dsPIC30F4011/4012 Family Silicon Errata and Data Sheet Clarification

The dsPIC30F4011/4012 family devices that you have received conform functionally to the current Device Data Sheet (DS70135F), except for the anomalies described in this document.

FIGURE 1: dsPIC30F4011/4012 DATA EEPROM

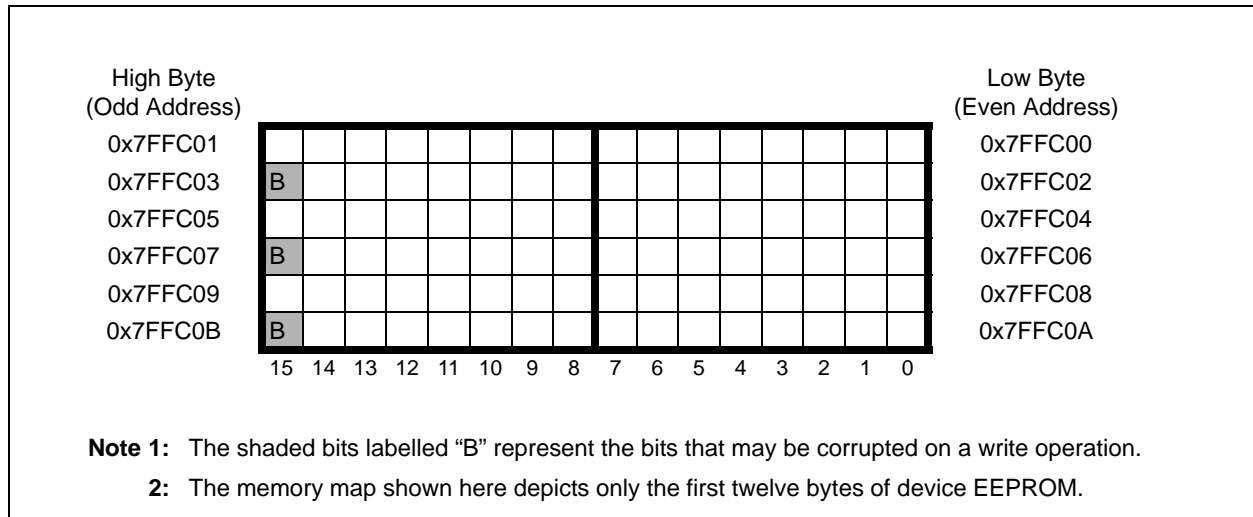
The Most Significant bit of every fourth byte in data EEPROM may be corrupted on any write operation. This write corruption may occur while using either PRO MATE[®], MPLAB ICD 2 or Run-Time Self-Programming (RTSP).

Figure 1 shows the first twelve bytes in data EEPROM and indicates the affected bits.

Use program Flash memory instead of data EEPROM to store constant data.

Use less than 16 bits in each word in the available word of data EEPROM, excluding the Most Significant bit.

Avoid using every fourth byte. Example 11 shows how the ASM30 assembler can be used to allocate data in the EEPROM under this constraint.
